COMMUNITY DEVELOPMENT DEPARTMENT REPORT

SUBJECT: Pollard Commercial Split - SHP
SHP-2026-0007

LOCATION: 6489 N. Levi Avenue, located in the SE
¼ of the SE ¼ of Section 21, Township
4N, Range 1W Parcel No. R7129171100

D. Short Plat (date: 5/15/2026)

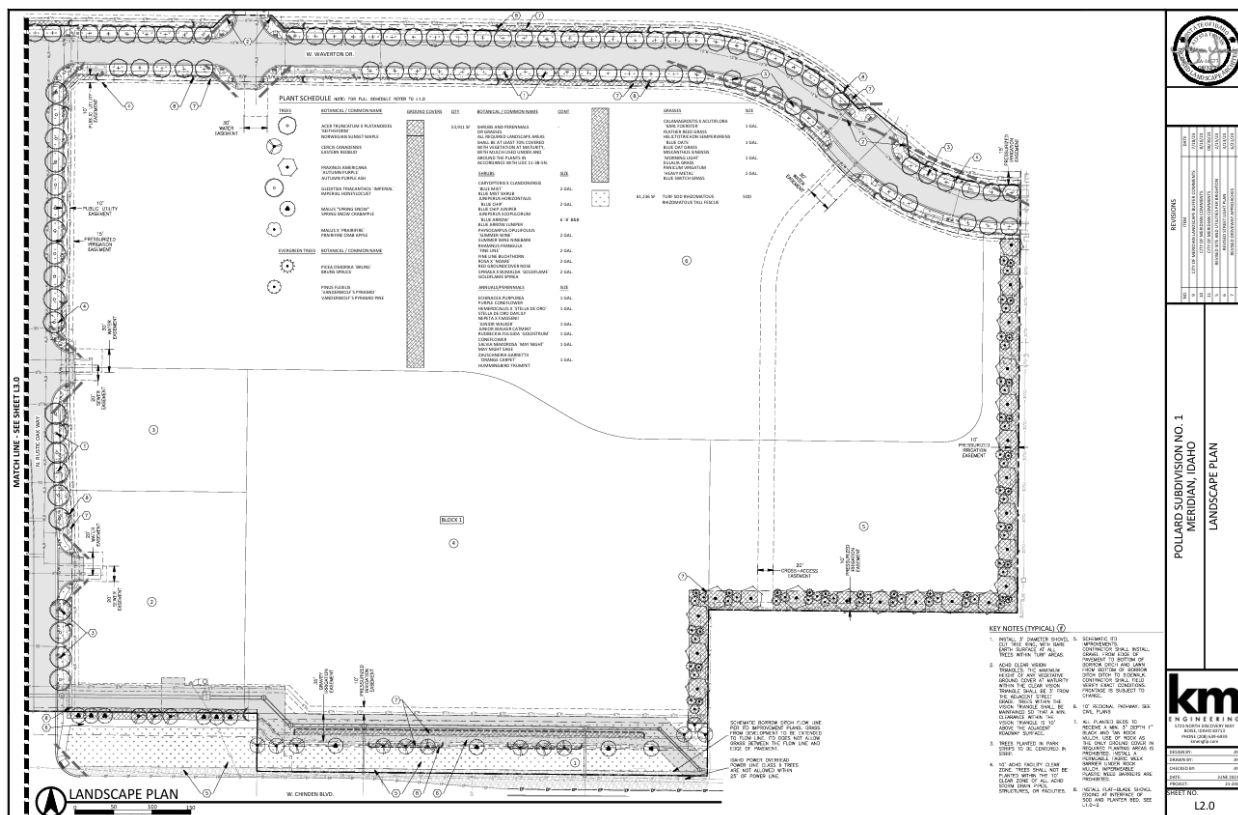
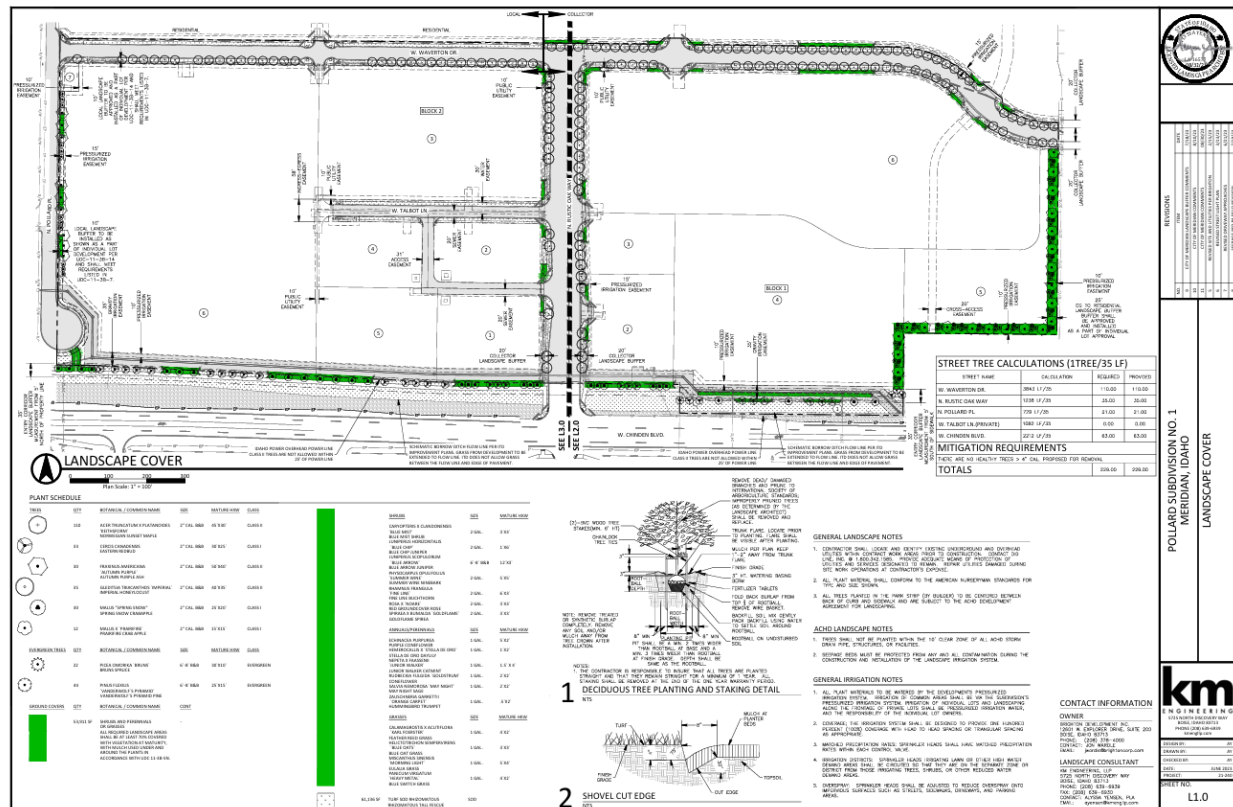
2. Future development shall be consistent with the minimum dimensional standards listed in UDC Table 11-2B-3 for the C-G zoning district.
3. The short plat shall include the following revisions:

- a. Add a note to the plat and show the front and rear ten (10) foot as well as the interior five (5) foot public utilities, irrigation and lot drainage easements for all lots if needed based on the new layout.

- b. Provide access and utilities to Lot 1, Block 1. Demonstrate how this will work with the new lot.
4. The existing landscaping along Chinden Boulevard shall be preserved and protected during construction on the property.

1. Water is provided by Veloia.
2. Area is subject to the Oaks Lift Station and Pressure Sewer Reimbursement agreement. For the commercial development, the ERUs needed will be calculated during the building permit review process. The reimbursement fee for the entire building(s) must be paid prior to the City issuing a building permit.
3. Sewer will need to be extended to the western parcel. Do not run sewer services through another parcel's lot
